moray offshore renewables ltd

Environmental Statement

Technical Appendix 1.3 C - Draft ES Consultation Responses

Telford, Stevenson, MacColl Wind Farms
and associated Transmission Infrastructure
Environmental Statement

Figure 1. Illustration of the potential change in the entrainment of coarse grained sediments during storms.

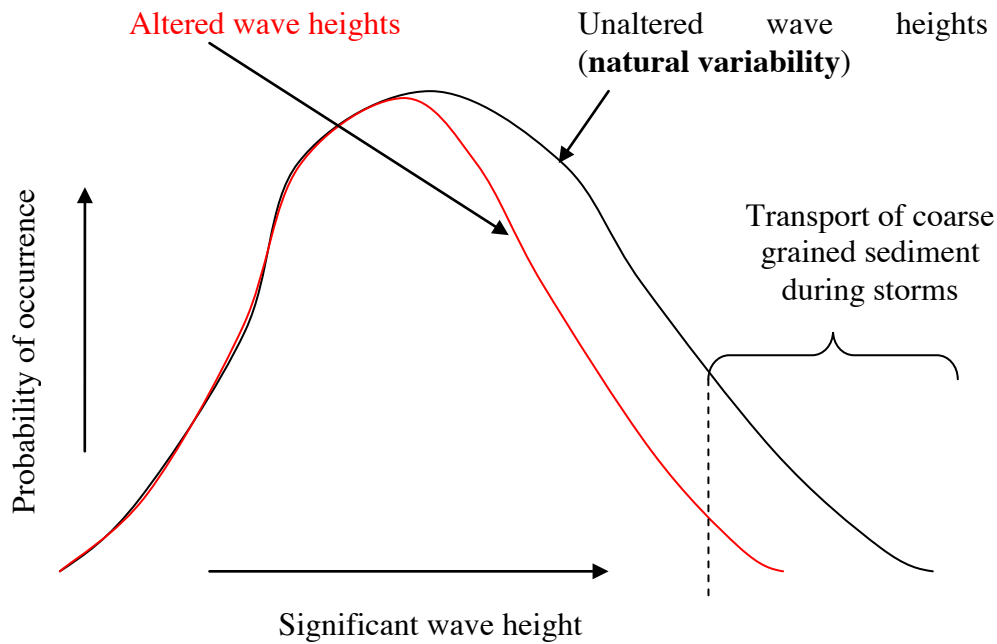
We have some concerns over the statement at the end of page 194, “Given no significant effect on the driving parameters, there can be no corresponding difference in the potential rates and directions of sediment transport through the site”. The effect on the driving parameters is expected to be, according to this ES, up to 19% decrease in the significant wave height. The ES argues that this decrease is within the range of natural variability, and that therefore there is no significant effect on the driving parameters. This could well be the case, it would be useful to review the relevant technical appendix to find out more, but it could also mean that some of the largest naturally occurring waves, for example 1 in 1 year storm waves, are reduced significantly. The ES mentions in section 7.5.4.1 (p. 71) that such storm waves are responsible for much of the wave driven transport of the coarser sediment. This may lead to a degree of sediment retention, i.e. net accretion, in the area. This is acknowledged to an extent at the beginning of page 195, but we would recommend that the statement above be altered slightly to acknowledge this possible effect of the reduction in significant wave heights. We would also recommend the removal, or alteration, of the statement “However, as stated above, the absolute difference in sediment transport attributable to the wind farm is less than the potential for natural variability over the same period” near the beginning of page 195. We would question the validity of the developer’s conclusion that there will be “no effect on the form and function of Smith Bank” (p. 195). It is acknowledged that the 19% change is a worst case scenario given particular wave forcing conditions, and that the possible effect is therefore very slight. It should still be acknowledged in the ES though. We would suggest that there is a potential danger here, when assuming that just because something is ‘within natural variability’ it is okay. In particular, this is a dangerous assumption when it is the extremes of the natural variability that are potentially the most important/significant, as is the case in this example. Figure 1 illustrates the above issue.

The section on ‘designated coastal habitats’ (p. 195) relies, to an extent, on the above assumptions. There may, therefore, need to be some rewording in this section to account for any changes made in response to the above concerns.
